INSPECTION REPORT  
Sedimentation Structure  
N10-B  
Kayenta Mine  
Navajo County, Arizona  
for  
PEABODY COAL COMPANY

Dames & Moore  
10139-011-22

Structure N10-B was inspected on September 7, 1985 by an interdisciplinary team of engineers from Dames & Moore. The purpose of the inspection was to assess the safety and general condition of the structure with respect to United States Department of Interior, Office of Surface Mining (OSM) regulations.

EXISTING  
MAXIMUM CROSS-SECTION  
A-A'  
N10-B

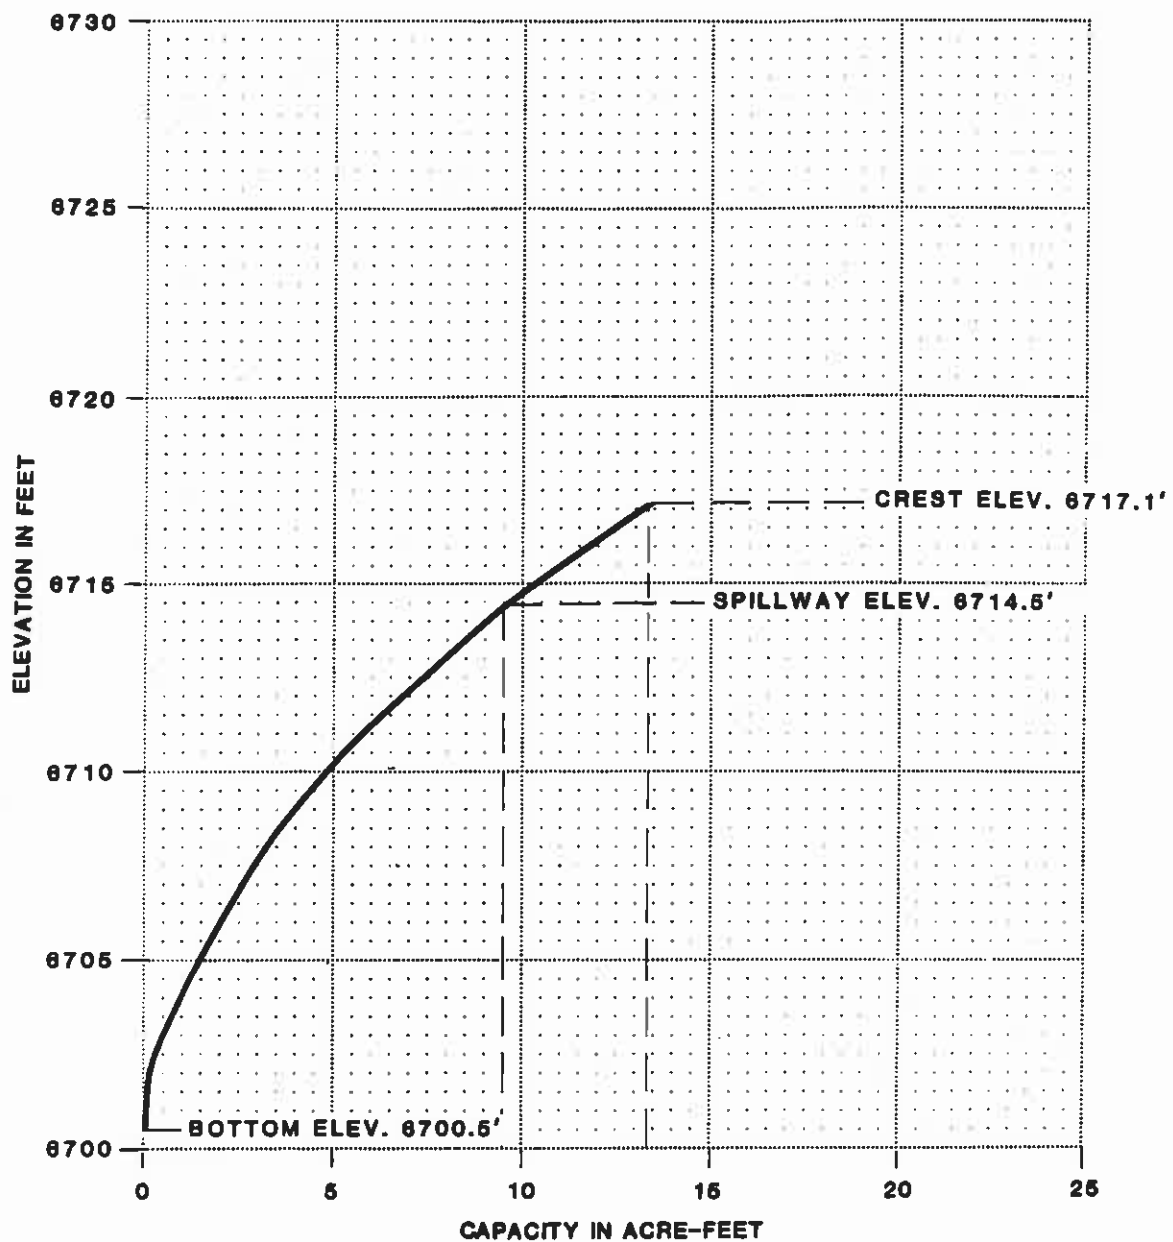
The inspection of Structure N10-B indicated that the geotechnical problems consist of rill erosion on the upstream and downstream slopes and the side slopes of the spillway channel; and cracks in the crest and downstream slope of the embankment. In addition, the slopes of the embankment are uneven. Correction of erosion is considered a periodic maintenance task and does not require remedial action. The embankment section with the

cracks should be repaired by excavating to the bottom of the cracks and reconstructing the embankment with compacted fill. The uneven slopes are due to, in our opinion, a lack of fine grading at the end of construction of the embankment and do not present a hazard to the stability of the structure. However, the slopes should be trimmed to prevent masking of potential problems in the future.

CHANNEL PROFILE B-B'  
N10-B

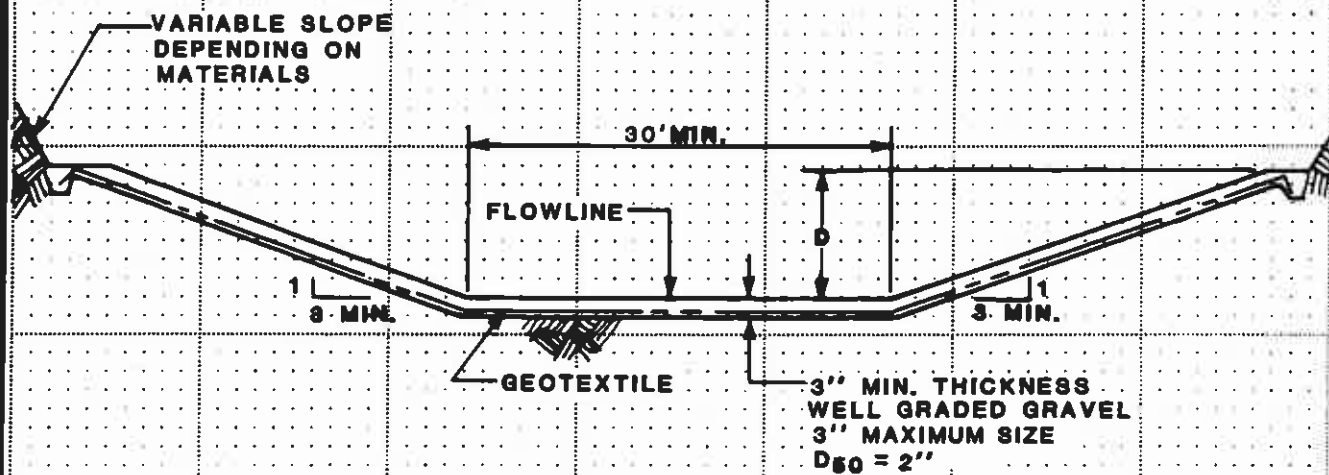
The storage capacity and spillway capacity of Structure N10-B are adequate; however, the spillway does not have an outflow channel or adequate erosion protection. A trapezoidal outflow channel should be constructed along the alignment B-B' shown in Plate 1. The channel profile is shown in Plate 4 and the required dimensions are shown in Plate 5. Both the spillway and outflow channel should be protected against erosion using geotextile and gravel as shown in Plate 5.
